**RE: Docket No. LC 76 – In the Matter of CASCADE NATURAL GAS CORPORATION, 2020 Integrated Resource Plan.**

Docket No. LC 76

2020 Integrated Resource Plan.

Staff's Opening Comments

Figure 1– Oregon Residential UPC Per Day vs. Redmond Daily HDD

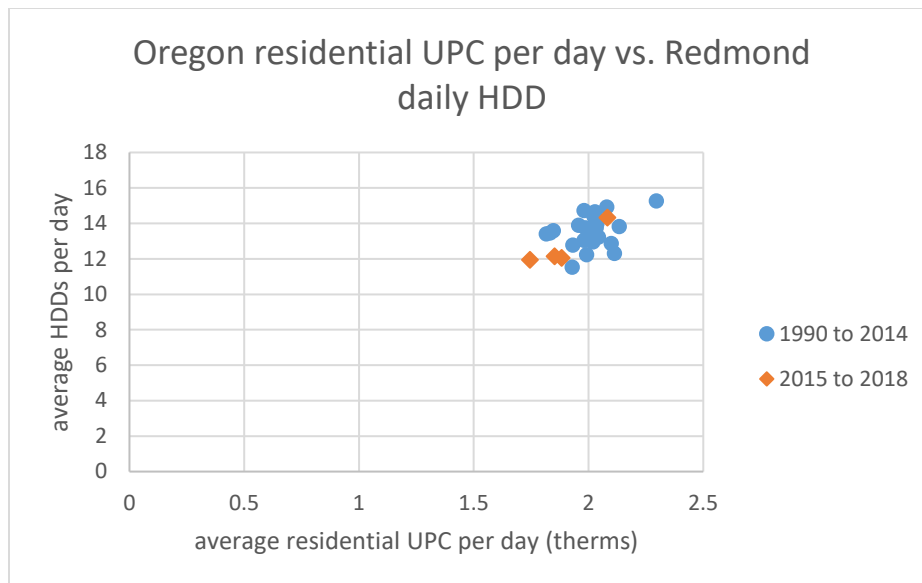
The scatterplot above shows that years that are colder on average have higher gas usage per residential customer. Although averaging over an entire year is a crude

measure, the scatterplot also hints that a forecasting model that computes the sensitivity of gas usage to weather might compute significantly different sensitivities depending on which years of data are used in the model. Using a forecasting model that can use a longer historical series of weather data would provide a more robust measure of the relationship between gas usage and weather.

Figure 2– Price Projections<sup>9</sup>

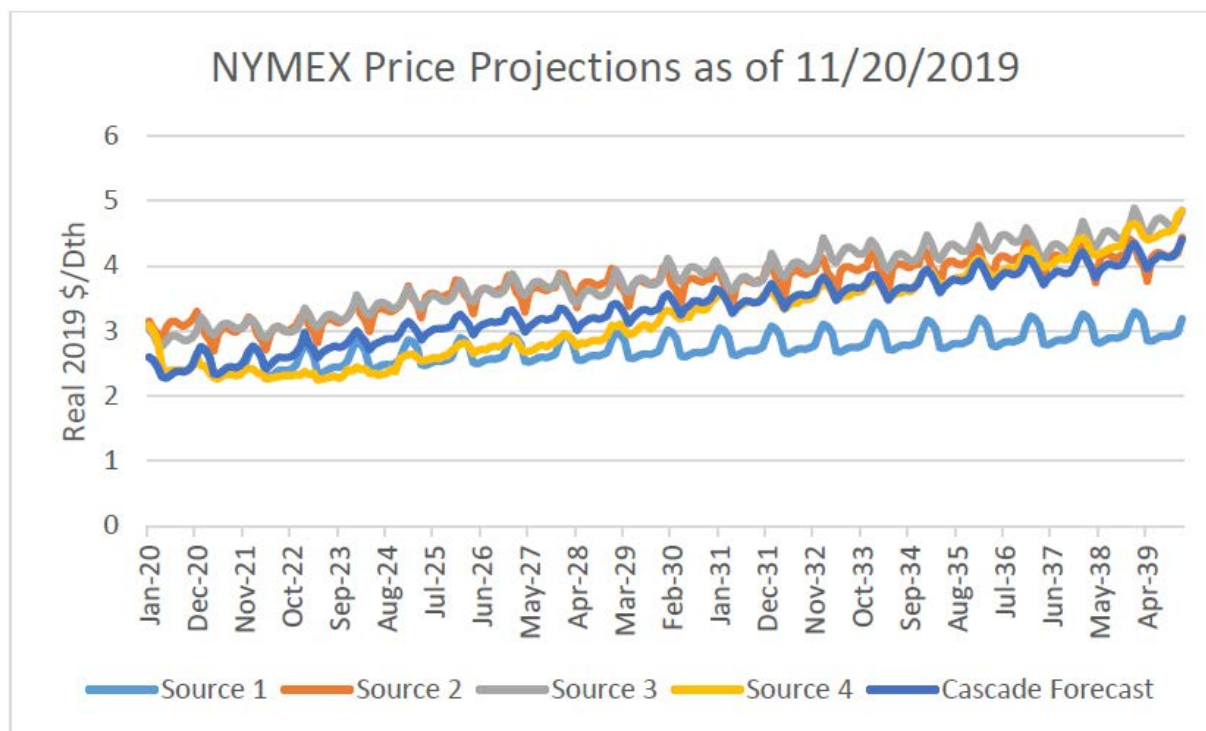
Staff generally does not take issue with the blending of several forecasts to generate a price forecast. However, Staff is worried about the Company’s implementation of the blended forecast for two reasons. First, it inappropriately uses an extrapolation of NYMEX futures prices as one of the long-term price forecasts ([Begin Confidential] [Redacted] [End Confidential]) in the graph above). Second, it introduces an Age Dampening Mechanism (ADM) that assigns an excessive weight to the NYMEX-futures-based forecast.

Staff finds that a forecast assuming gas prices will escalate at the expected rate of GDP growth for fourteen years is inappropriate. There is a wealth of other information to consider when forecasting prices. For example, Avista's 2018 IRP noted the wide range of information considered over the planning timeframe, including "regional supply/demand issues, weather conditions, storage levels, natural gas-fired generation, infrastructure disruptions, and infrastructure additions."<sup>13</sup> These considerations are all lacking in a simple escalation of near-term NYMEX futures prices.

Figure 3: Annual Savings Comparisons by Scenario<sup>26</sup>

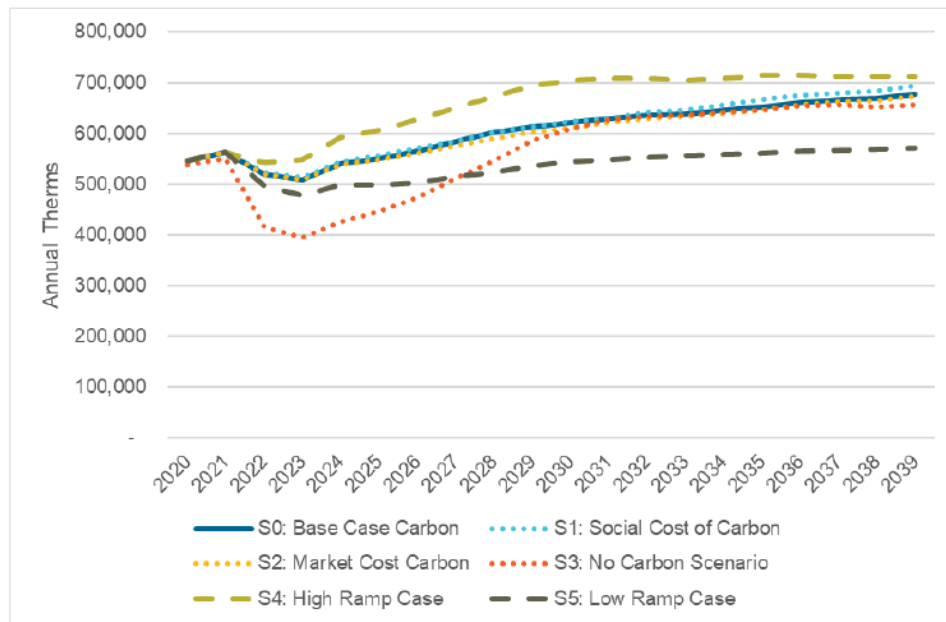
11 percent below the base case. However, as seen in the following figure from the 2020 IRP, three of the alternate carbon scenarios are clustered close to the base case.<sup>25</sup>

This figure indicates that there seems to be little impact between using the base case carbon scenario, social cost of carbon, and market cost of carbon. The figure also shows that having no carbon cost would have an impact initially, but would revert to the baseline scenario in later years. Staff will follow up with the Company and Energy Trust to understand these modeling assumptions as part of Staff’s IRP analysis.

Figure 4: Comparison of energy efficiency targets and actual acquisitions<sup>27</sup>

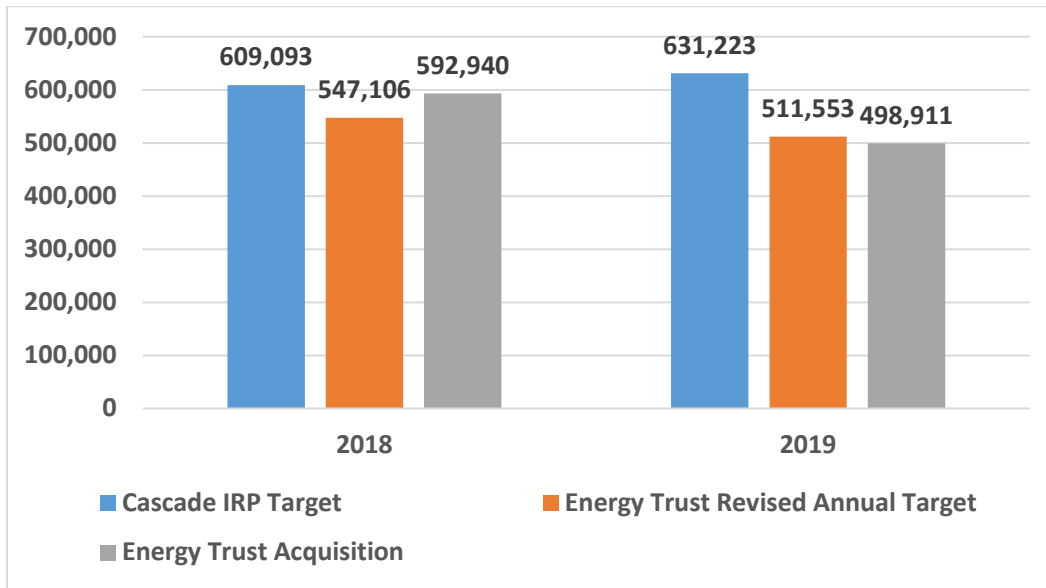
In the 2020 action plan, the Company set energy efficiency goals. As Energy Trust updated its forecasts for each budget cycle, the forecast had declined from the initial forecast provided in the 2018 IRP. The following figure illustrates how energy efficiency forecasts have changed, and how the actual acquisition also varies from both the IRP forecast and the target set through the budget process.

As demonstrated in the graphs, while the 2020 IRP forecast starts lower than in the 2018 IRP, it suggests increased savings potential in the future. The 2020 energy efficiency forecast was created in 2019, however, which means it does not reflect assumptions based on COVID-19 impacts. Staff will be following up to review the longer term trends with Energy Trust, and compare the 2020 IRP action plan with the 2021 Energy Trust action plan once it is finalized in early December.

Figure 9-28: Deterministic Vs. Stochastic Pricing

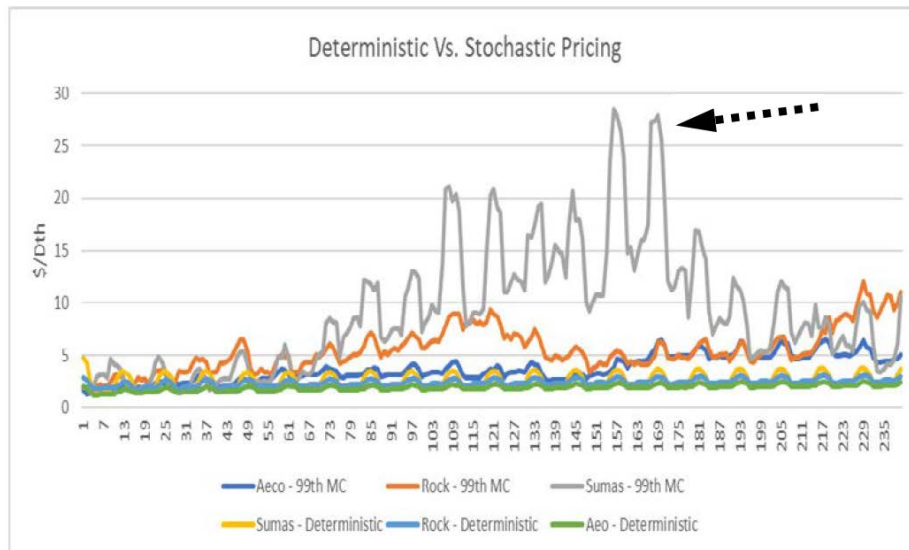
In the first month, the Company models NYMEX gas prices as randomly above or below their forecasted price. In the second month, the price is randomly above or below its first month price. Thus from month two onwards, the price can randomly move farther and farther away from its expected price, although on average the quantity of positive and negative price shocks should roughly balance out. The fact that prices build upon each other over time can create odd results. For example, the Company's stochastic analysis has a price above \$25 per dekatherm in some Monte Carlo draws. This is significantly above 99<sup>th</sup> percentile of a normal distribution since there is relatively low variance and a mean of about \$3 per dekatherm. For reference, Staff pastes a copy of Cascade's Figure 9-28 below with emphasis arrow added:

In its response to Staff IR 52, the Company states, “The source of the numerous spikes in the Sumas forecast [in Figure 9-28] is the relatively high historical volatility that is applied to the model, caused in part by the Enbridge explosion at the end of 2018.” Staff submitted four information requests on the topic. Staff is submitting additional information requests to explore the impact of the dataset encompassing the time-period of the Enbridge explosion, and Staff will report the findings of this exploring in Final Comments.
